**Operator: Highpoint Operating**  
**Location Name: Randall Creek 30 SE**  
**Loc ID: 416280**  
**Inspection: 696306047**

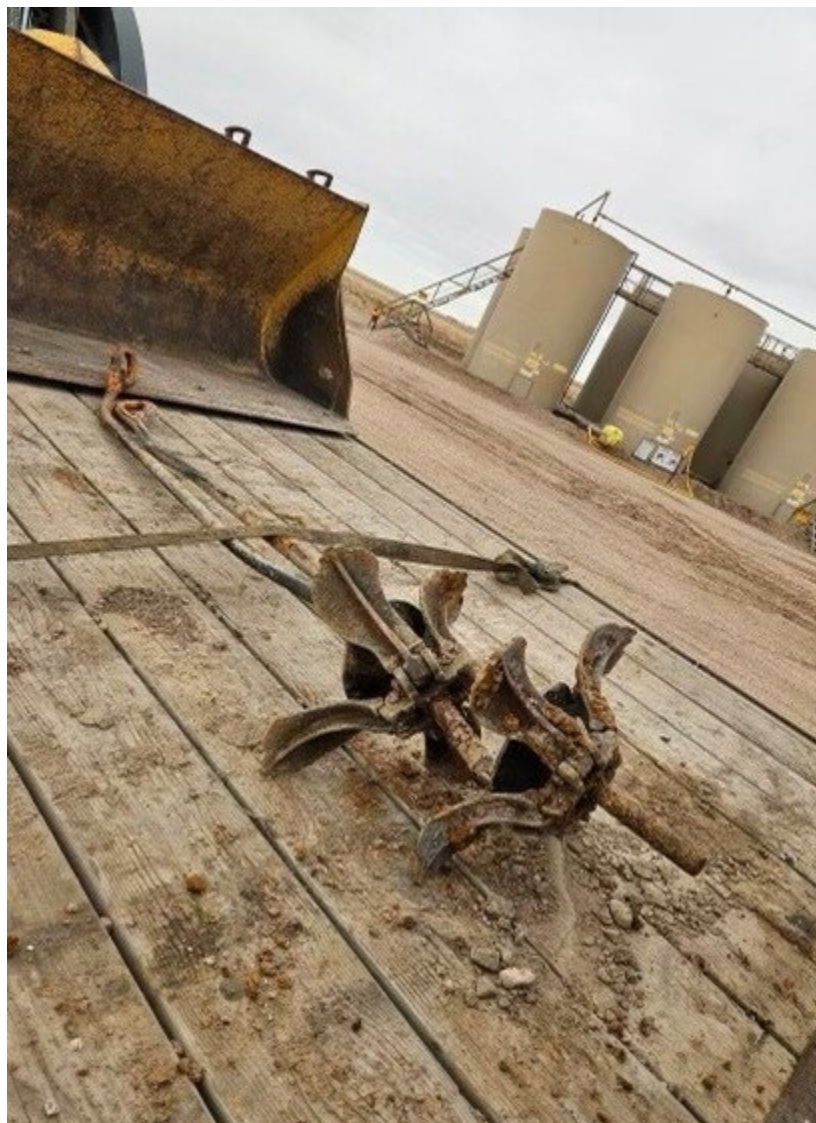
**CA:** Northwest and Southwest Deadman Anchor not marked. See photos. Install proper guy line markers per Rule 1003.a.

**CA Resolution:** Deadman Anchors have been removed to comply with Rule 1003.a.
